# Town of Hilton Head Island **Design Review Board Meeting Tuesday, March 14, 2023 – 2:30 p.m. AGENDA**

- a. Final
  - **DRB 000542-2023 Holiday Inn Express** The proposed hotel addition/renovation will include a new Porte Cochere entryway and tower infill element.

#### Holiday Inn Express – Tanglewood Drive Improvements

## **DESIGN TEAM/DRB COMMENT SHEET**

**EXTERIOR ELEVATION - FRONT ENTRY**

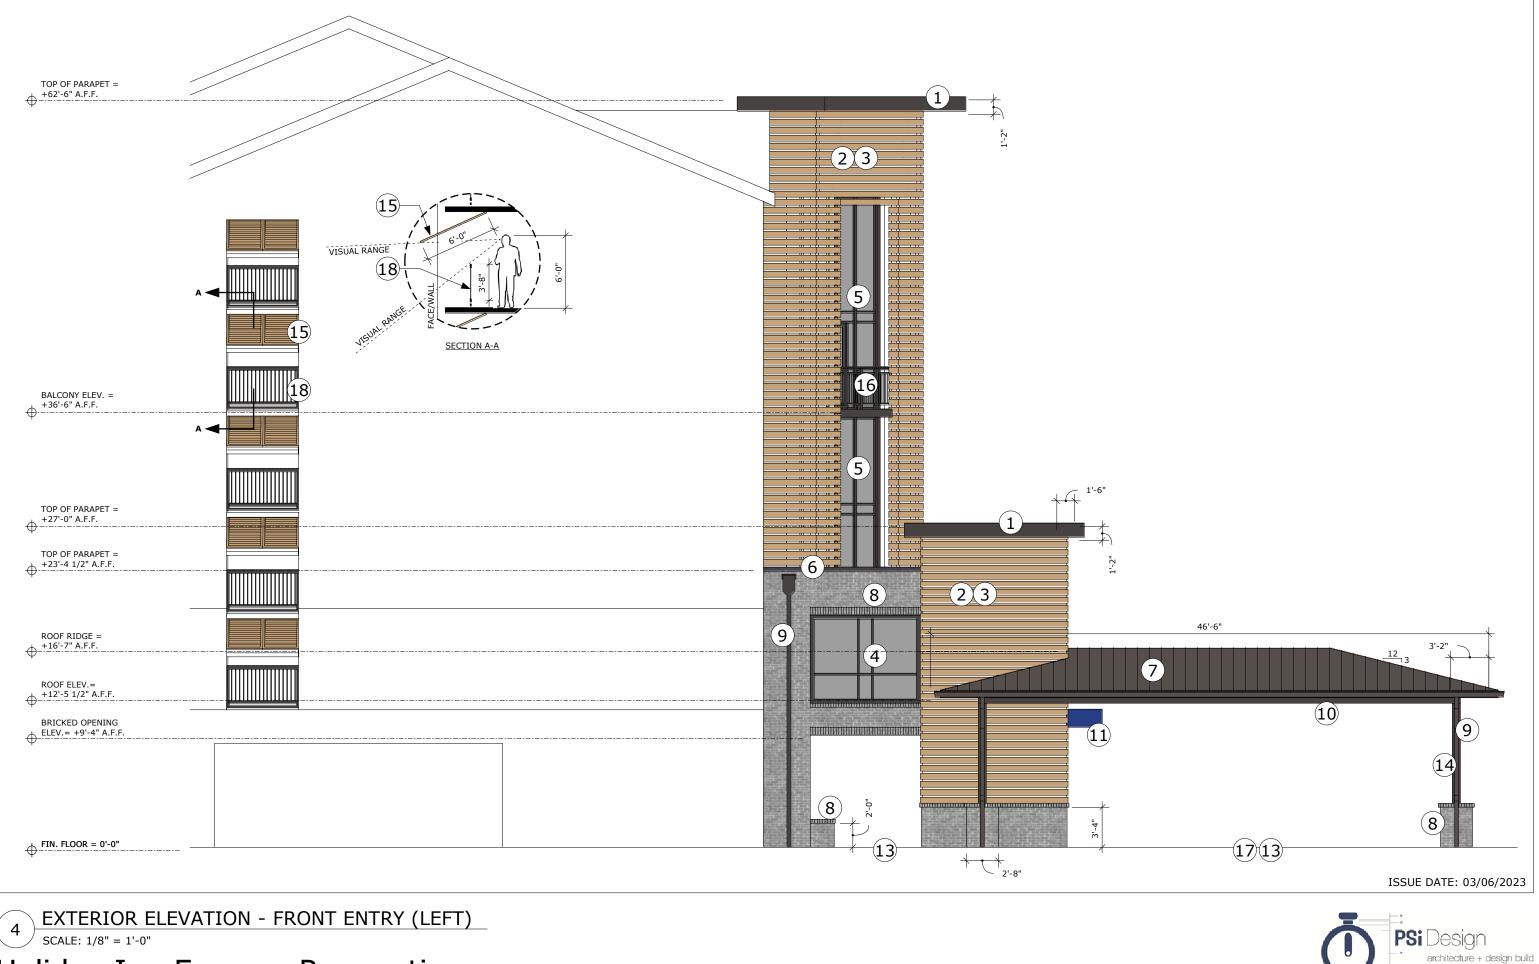
- 1. Reduce the scale of the brick column base on the Porte cochere. Create a tiered size for column bases from the Porte cochere to the columns under the new breakfast area by adding a cap detail to those columns at the larger size.
- 2. Modify the detail for the attachment of the Bahama Shutter to the building. The proposed detail will create a void/space between the top ceiling of the hallway and the top shutter creating the opportunity for birds to nest.
- 3. Check that proposed standing seam metal roof and metal roof caps can be matched in color if they are from different manufacturers so that the colors match.
- 4. Match new standing seam metal roof to the existing gage and width of the existing panels.
- 5. Modify lighting fixtures proposed on tower element due to scale of tower for staff approval. Recommend uplighting from roof element.
